Cliffe Lane, Gomersal

Highway Response Report

PROJECT TITLE: Cliffe Lane, Gomersal
REPORT TITLE: Highway Response Report
PROJECT REFERENCE: 152130
DOCUMENT NUMBER: 003
ISSUE NUMBER: 01
DATE: March 2024

TITLE: **SITE PLAN LAYOUT**

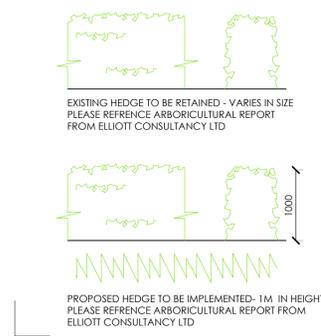
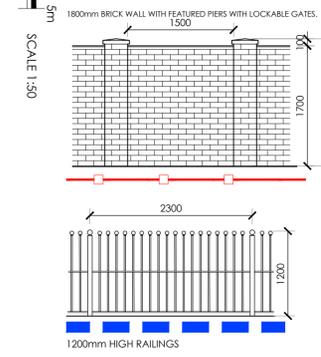
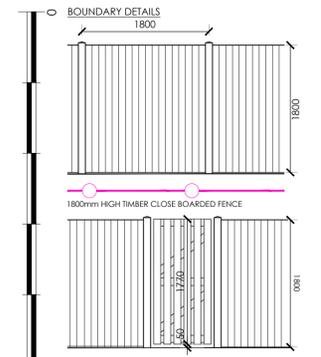
Visitor parking will need to be better spaced across the site at a rate of 1 per 4 dwellings, Adoptable visitor parking should be laid out parallel to the adoptable carriageway.

The handwritten annotations of some the house types are difficult to read particularly M3(3 bed with garage) and N3(4 bed with garage). Can the applicants confirm the M3 house types have 2 off-street parking spaces and N3 have 3.

The width of the potential access to the development site to the east of the site needs to be specified. An adoptable shared surface carriageway is typically 6.7m in width to include a 5.5m wide carriageway and 0.6m hard margins.

21 visitor bays are to be provided throughout the site and the location and layout of these are shown on LOROC Architects site plan attached at **Appendix A** for ease of reference.

Please refer to LOROC Architects site plans and housing schedule.

Details and dimension of this access are shown on LOROC Architects site plan. 5.5m carriageway and with 0.6m hard margins can be achieved.

Project Title	Cliffe Lane Gomersal			
Drawing Title	Swept Path Analysis			
Scale	1:500	Drawn By	SB	
Drawing Size	A1	Checked By	KS	
Date	July 2023	Approved By	KS	
Drawing Number	152130-002	Rev	A

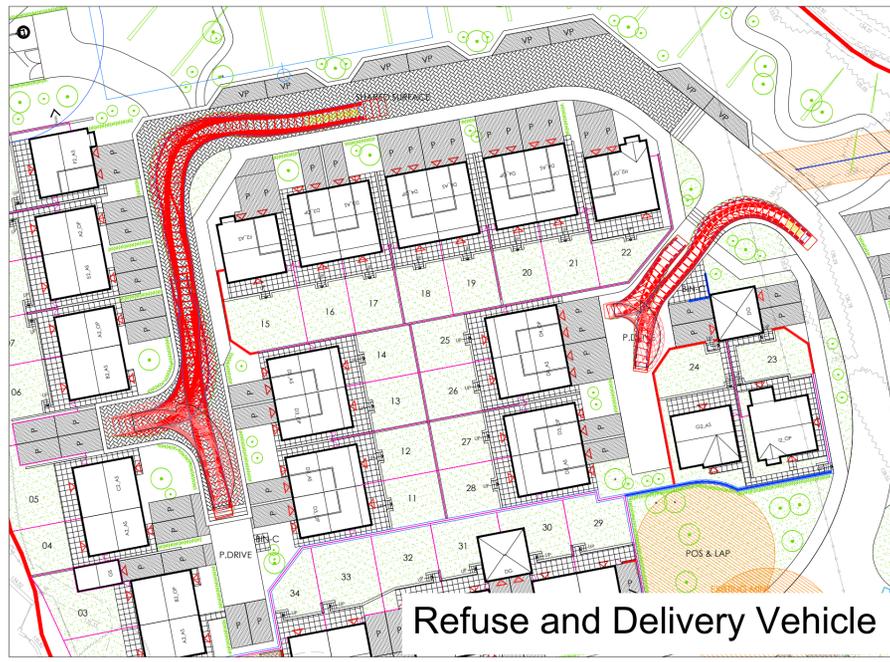
A plan showing swept paths and visibility needs to be provided for our review. This plan must also be annotated with dimensions of the proposed road widths.

This information was included within the Transport Assessment submitted with the planning application. These drawings have, however, been updated to reflect the layout changes. Drawings 152130-002A, 152130-003A, 152130-004 and 152130-005 prepared by Sanderson Associates provide this information and are attached at **Appendix B**.
